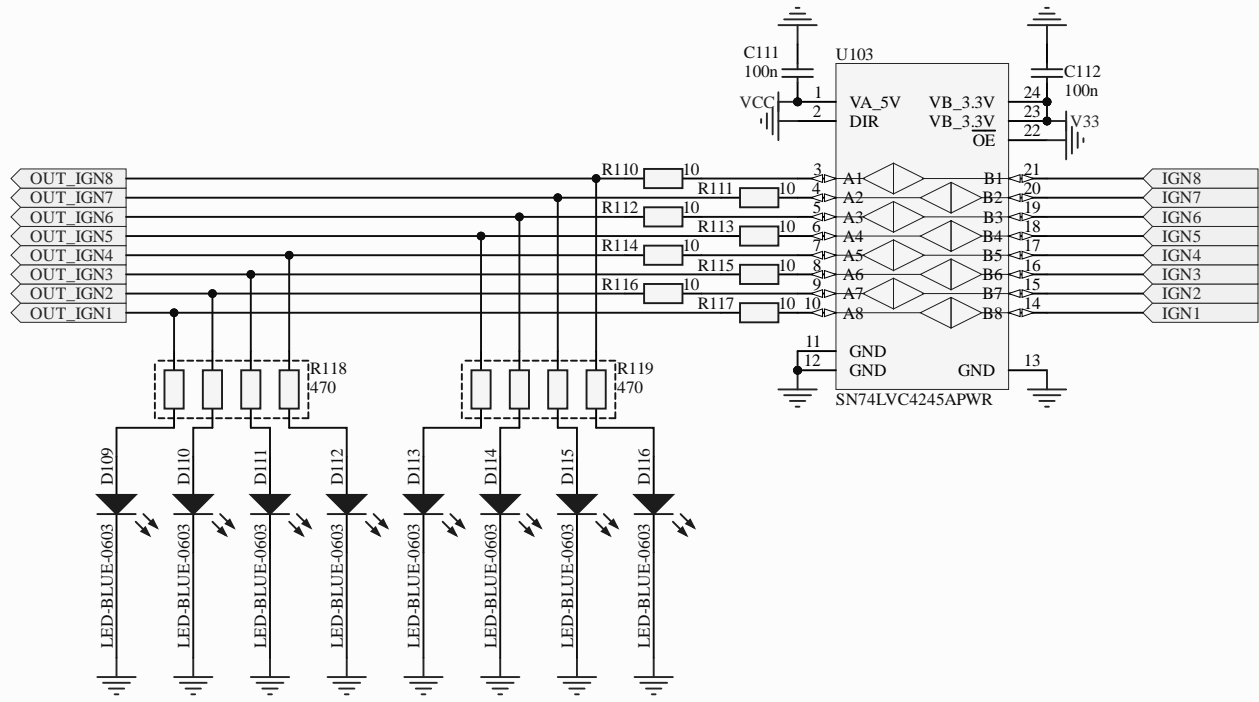
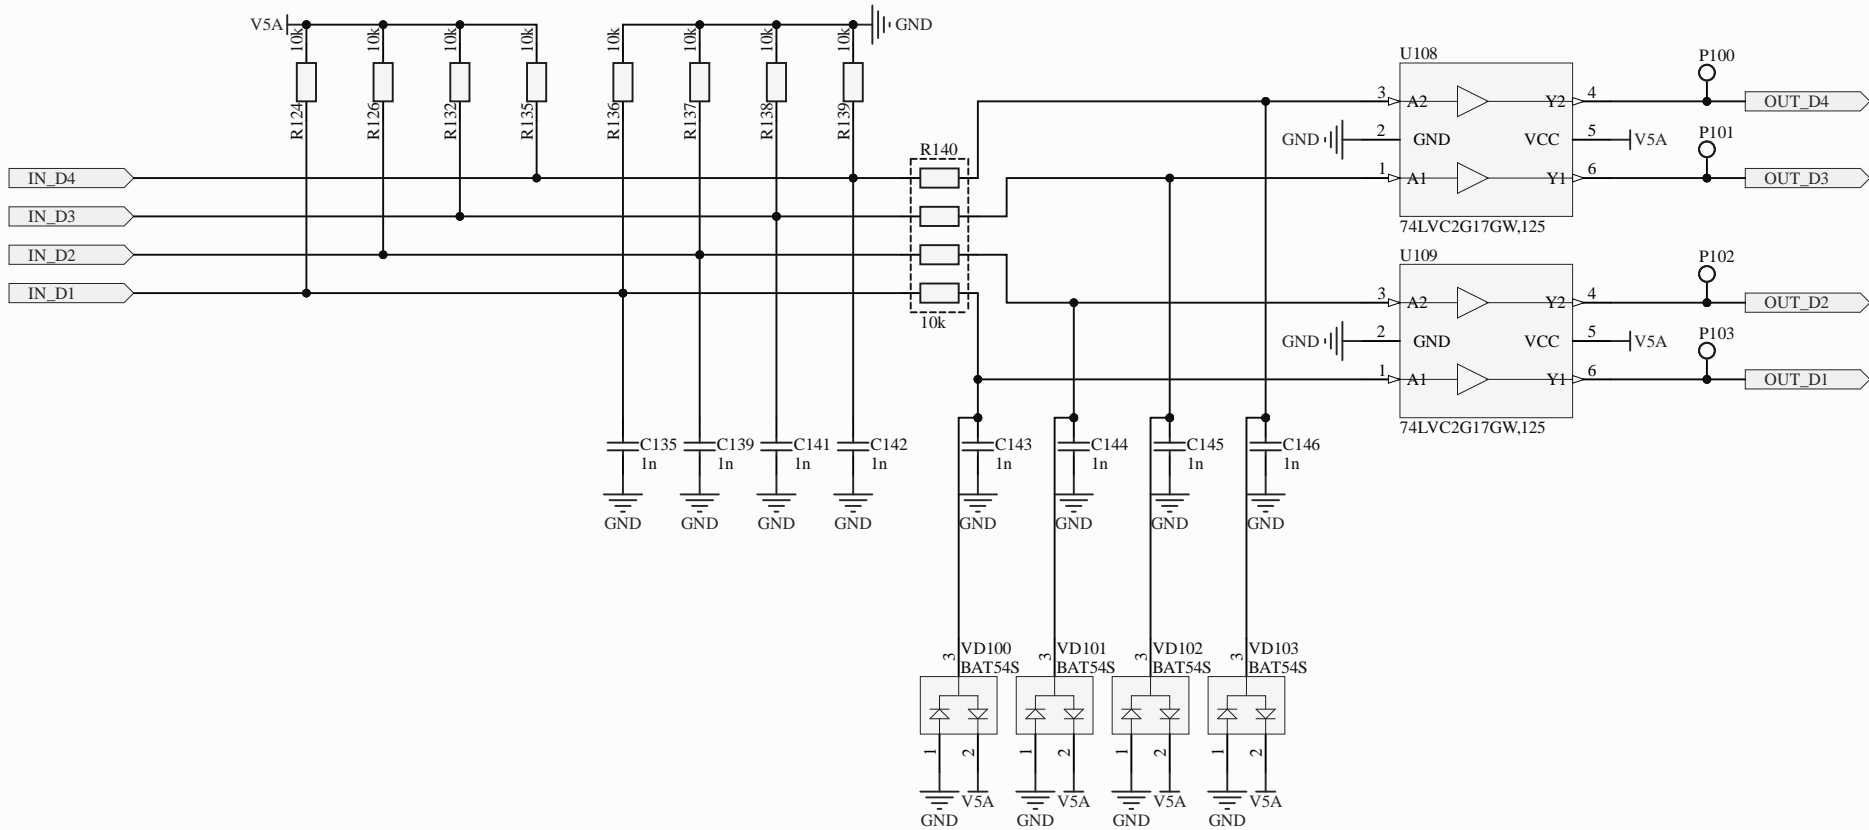
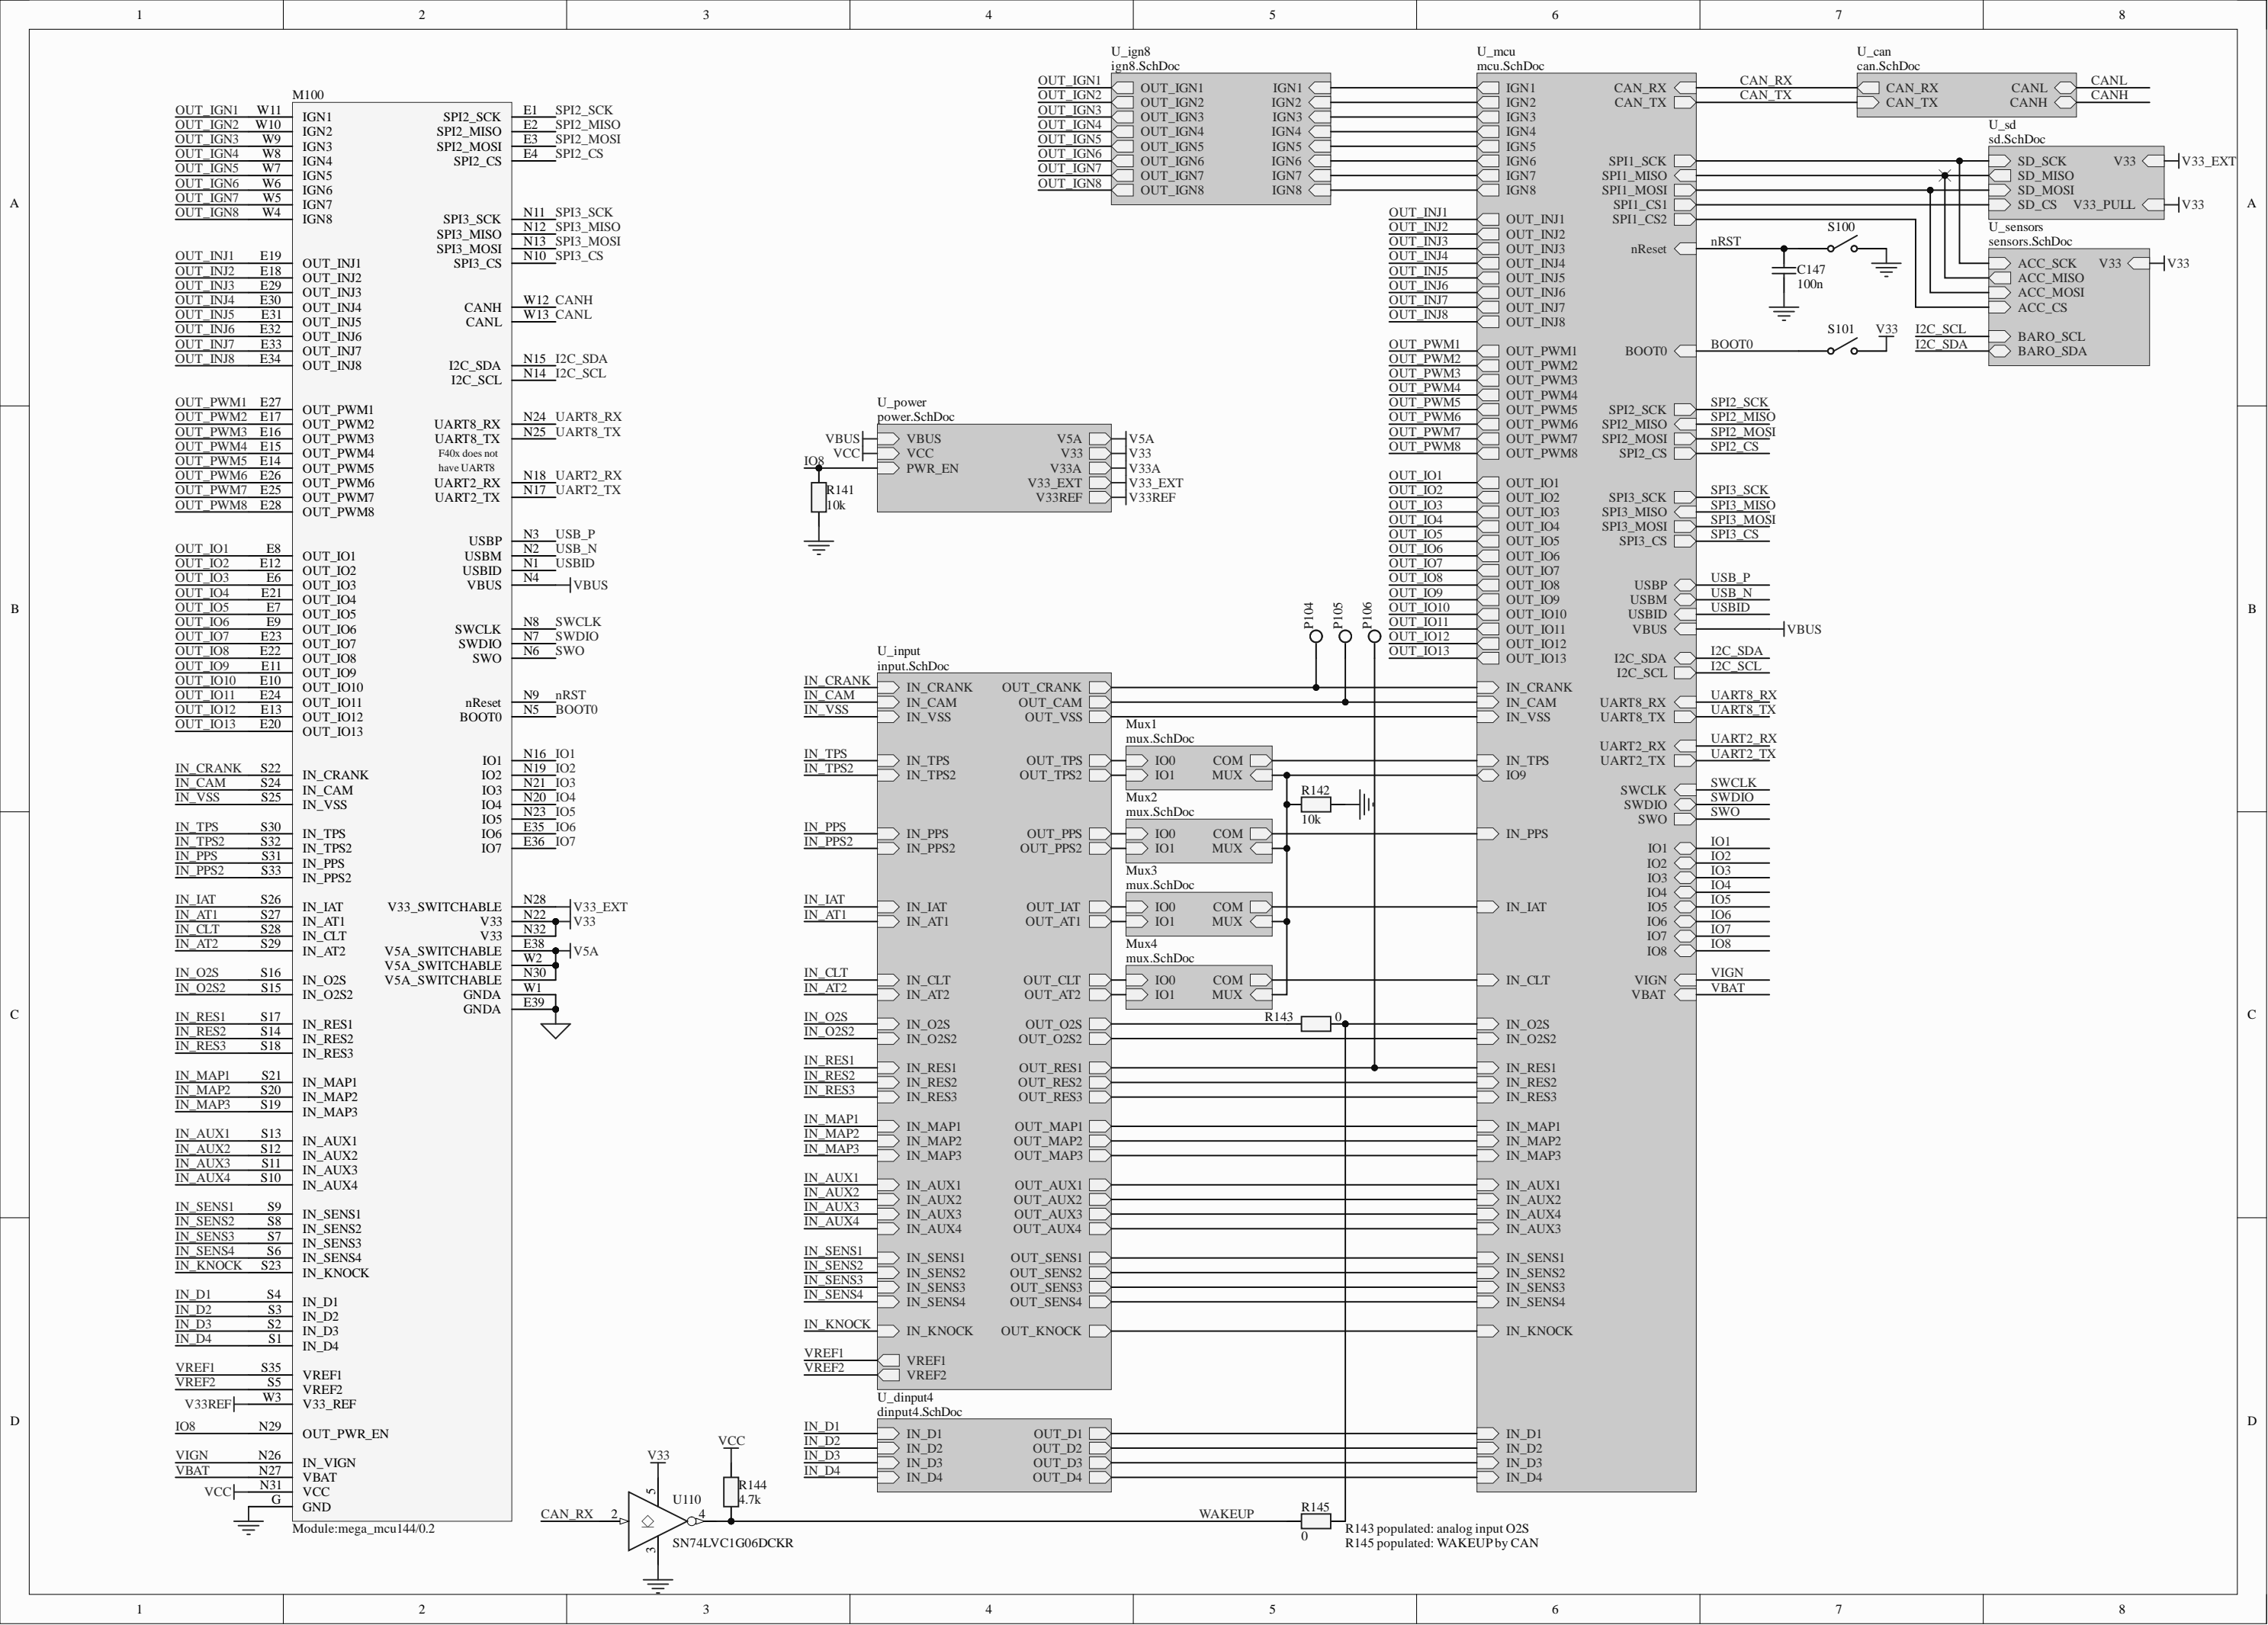
*A20-A23 are duplicated for ADC3
 *VIGN input is unprotected!
 *D5 is digital-only on F429! (EINT11)
 *A20-A22 are duplicated for COMP1/2

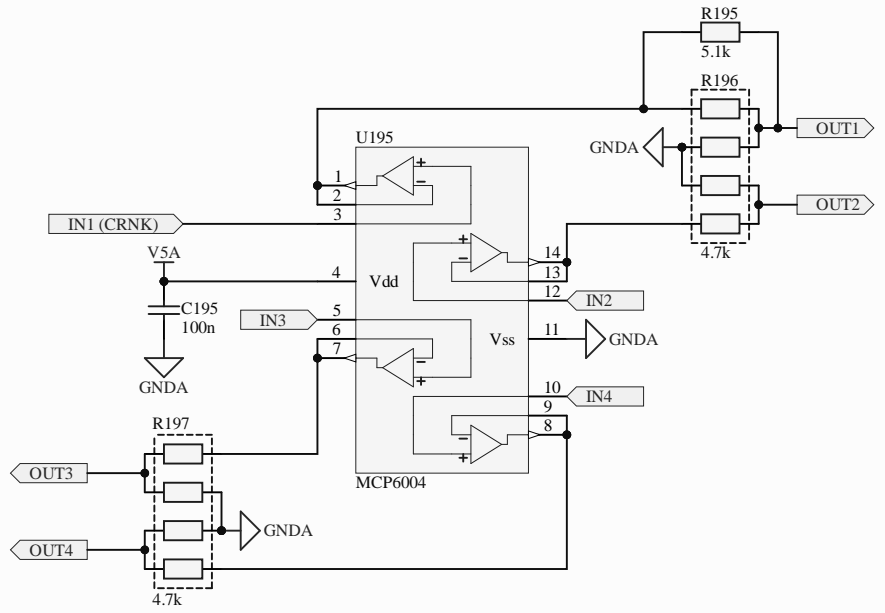
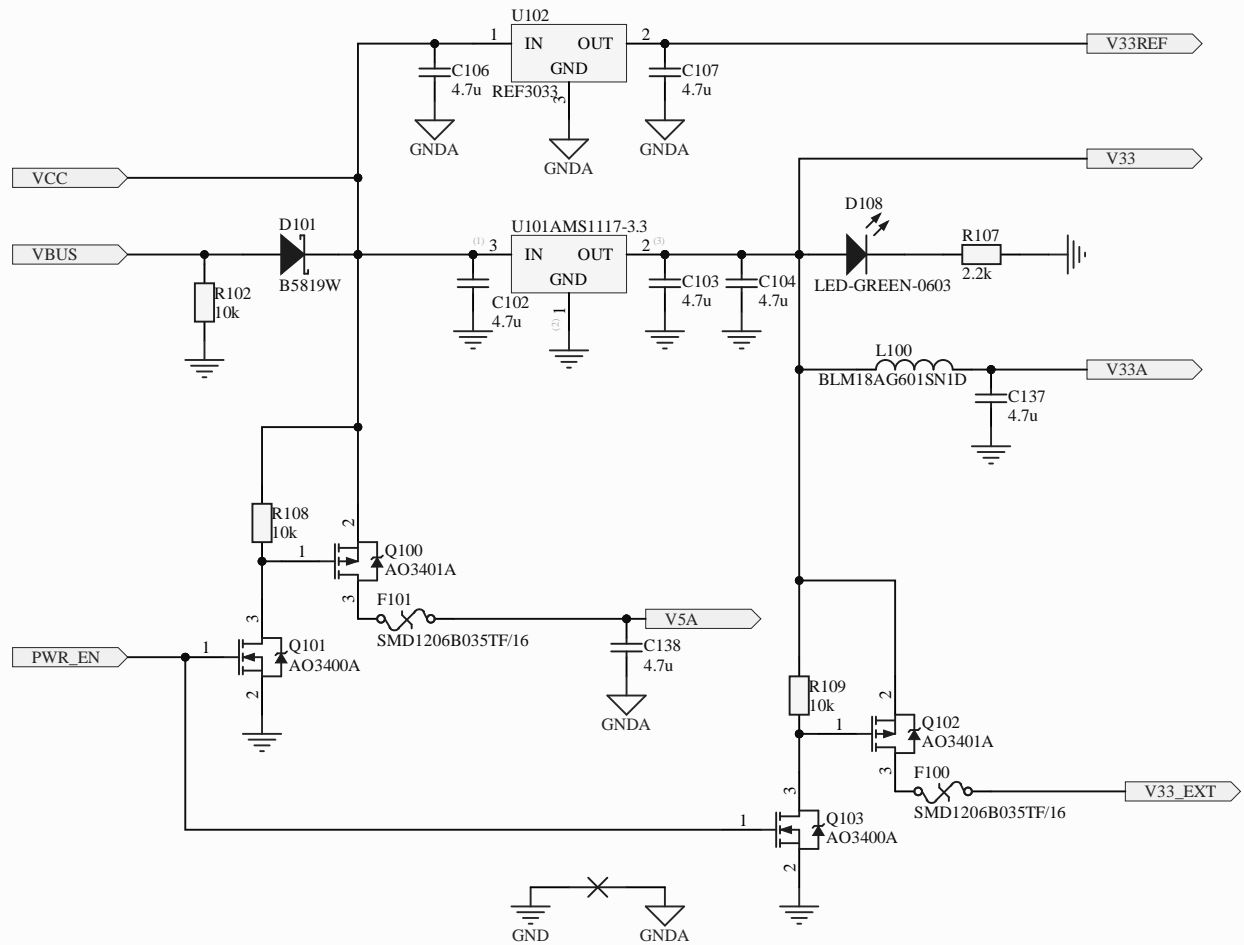
More accurate threshold for "raw" connection of VR sensors
